RE: RAWP Addendum 2/Response to Department Comments Letter (December 9, 2025)  
Rhode Island Recycled Metals  
434 Allen's Avenue  
Providence, Rhode Island  
Plat Map 47 / Lot 601 & Plat Map 55, Lot 10  
RIDEM File No. SR-28-0143

This correspondence is provided as the Remedial Action Work Plan (RAWP) Addendum 2 requested in the Department's December 9, 2025 comments regarding the Rhode Island Recycled Metals (RIRM) facility prepared by Lake Shore Environmental (LSE<sup>1</sup>) and dated August 13, 2025. Department comments shown below are in italics.

RE: Design Engineering Report  
 Rhode Island Recycled Metals, Providence, RI  
 Project # 3543-001, RIDEM File No. SR-28-0143

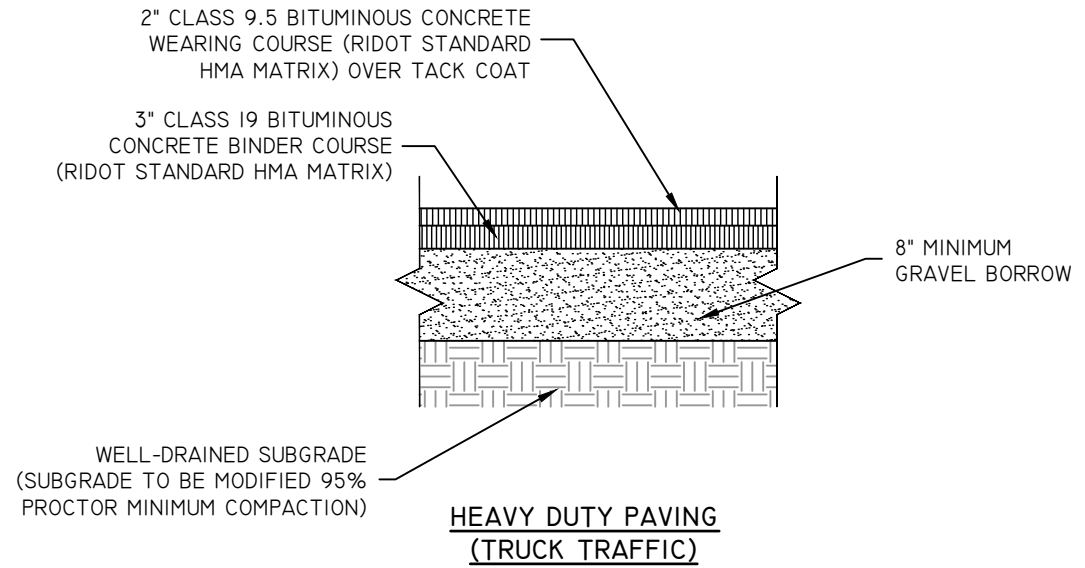
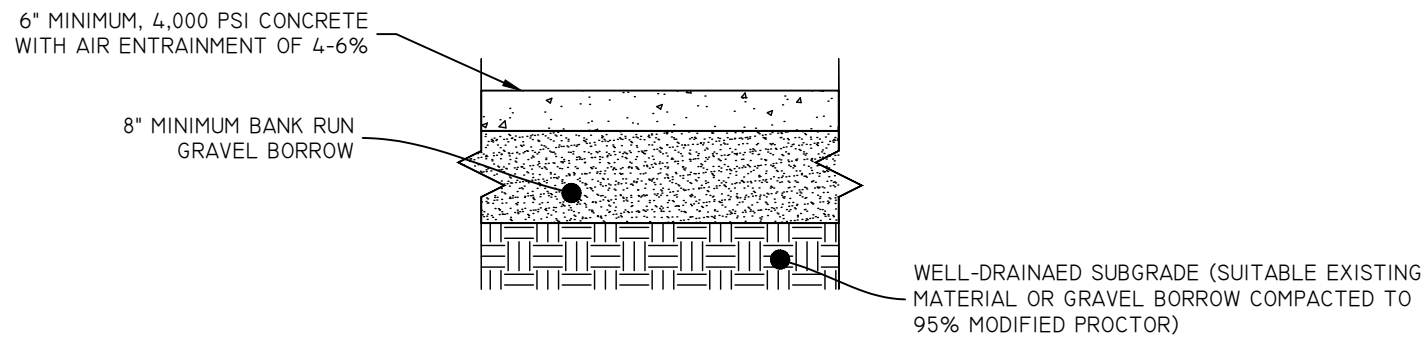
- b. *Please update the “Cap Specifications” detail drawings (Attachment C) to be consistent with the above-referenced engineering report. Ensure that all potential engineered barriers are included and that the drawings are prepared under the supervision of and stamped by a Rhode Island Registered Professional Engineer, in accordance with § 10.10.10(A)(5) of the Remediation Regulations.*

The updated detail drawings are included herein as Attachment A and include the asphalt caps, concrete caps, and the stormwater basin area.
